1. DETAILS OF THE DEVELOPMENT

Ref: 20/03799/PRE
Location: Zodiac Court, London Road, 161-183 London Road, Croydon, CR0 2RJ
Ward: Broad Green
Description: Phased redevelopment of the current site to provide residential and commercial development
Applicant: Mitheridge Capital Management LLP
Agent: Avison Young
Case Officer: James White

2. PROCEDURAL NOTE

Image 6: Typical floor layout – 4th floor

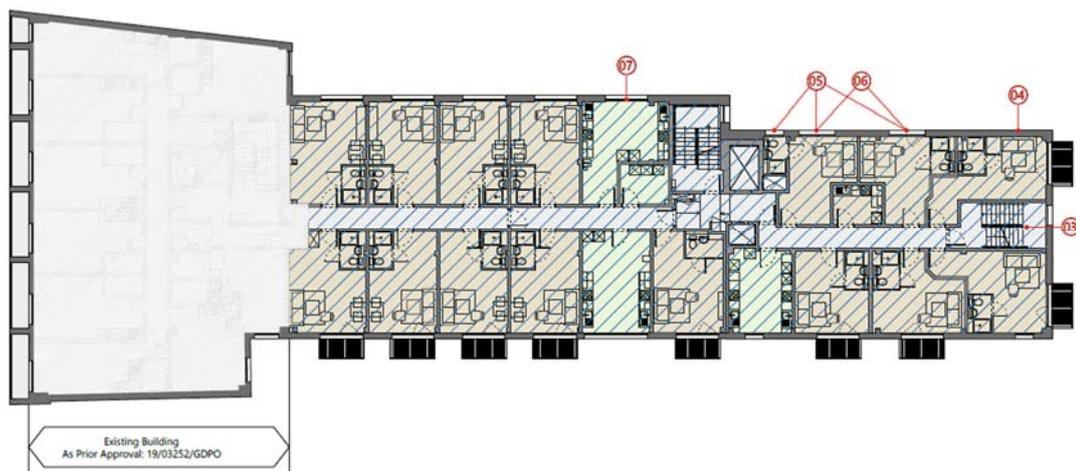
A number of changes were proposed which effectively regularise the necessary layout changes that occurred as a result of prior approvals granted subsequent to the issue of planning permission.

Image 14: Bay study of LHA and proposal

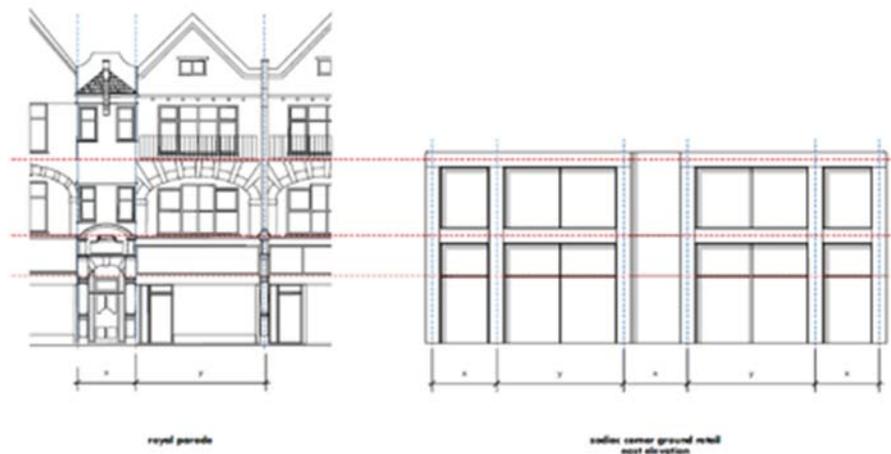
- 6.29 The height of the plinth is of a scale that is equivalent to the Royal Mansions opposite and the proposals seek to visually match key facade divisions within the elevational hierarchy of the parade with a simple and contemporary language.

- 6.30 A contemporary language is supported to tie in with the rest of the proposals and existing Zodiac buildings. However, officers have asked for further design development. The large expanses of glazing, dominant primary structure and subtle secondary partitioning breaks do not seem an adequate compliment to the elevational structure and grain of the units opposite. In addition, it gives an overly generic commercial appearance.

- 6.31 Further design work is required. This should be through nuancing the developing architectural language of the overall scheme to respond the LHA context and the applicant's aspirations to restore the street scape along this section of London Road.

- 6.32 The design of the plinth would benefit from detailed precedent study of similar contexts to understand how contemporary responses have been articulated. Officers in particular are of the view the proportion of solid to void (glazing) needs to be reviewed as part of this. The quantum of glazing is also a concern regarding the activity of these frontages given the likely type of retail occupier.

Image 19: proposed amenity and play space

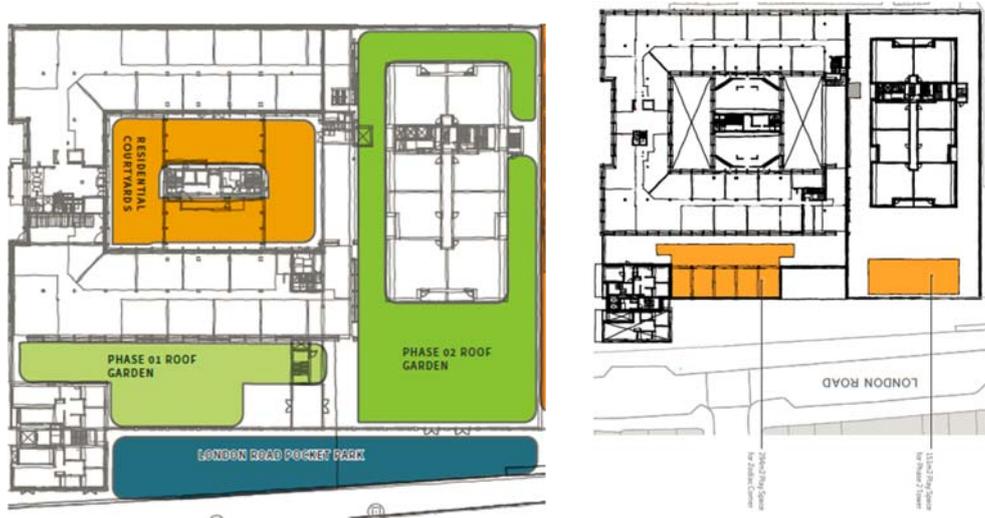
6.72 Preliminary landscaping plans have been provided demonstrating that communal amenity space (green shading in image below left) and playspace within that (orange shading in image below right) would be provided primarily on the deck level, which is accepted. Although the deck location aids natural surveillance from the proposed units, a greater level of defensible space is required for future occupiers on the same level as the internal privacy does not currently appear well managed. Calculations of playspace have not been carried out, although this is not expected at this stage they are based on the potential child yield of the

final submission. However, it does appear that space could be made to increase these areas if needed.

Image 20: phase 1 drawing with proposed temporary delivery from London road onto land in front of building.

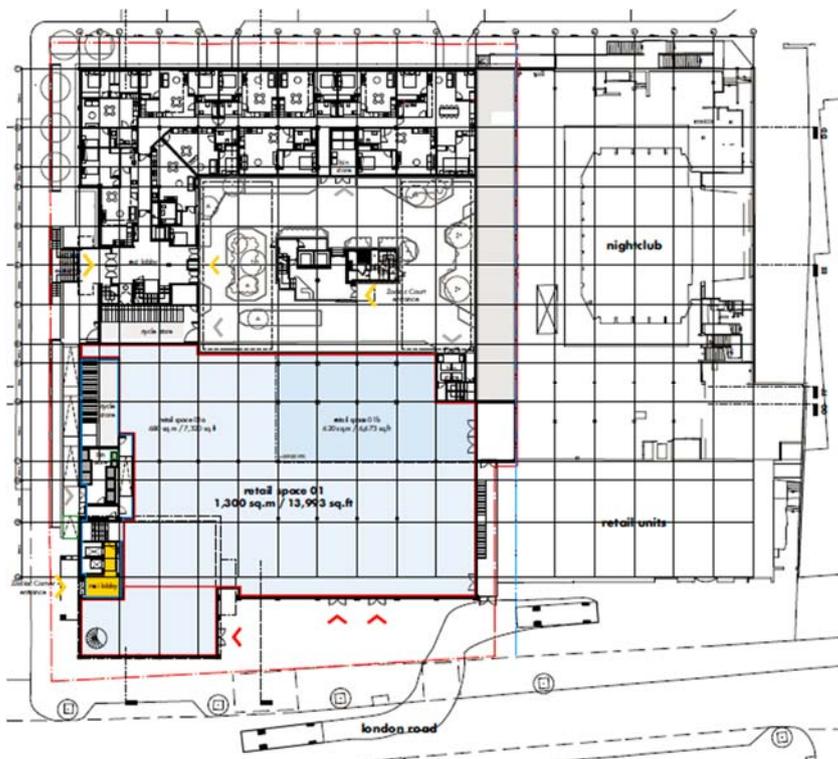
- 6.102 At the moment however, officers are concerned about the transitional arrangement between the phases. The first phase does not benefit from the dedicated delivery entrance and turning area (under the commercial unit) and relies upon the frontage area of the site (see image below). This has both significant townscape and highway impacts. Should Phase 2 never be started then there is the possibility that the transitional arrangements would be permanent. Therefore any transitional arrangements have to be acceptable as they could be the end-state; this requires further work and justification.
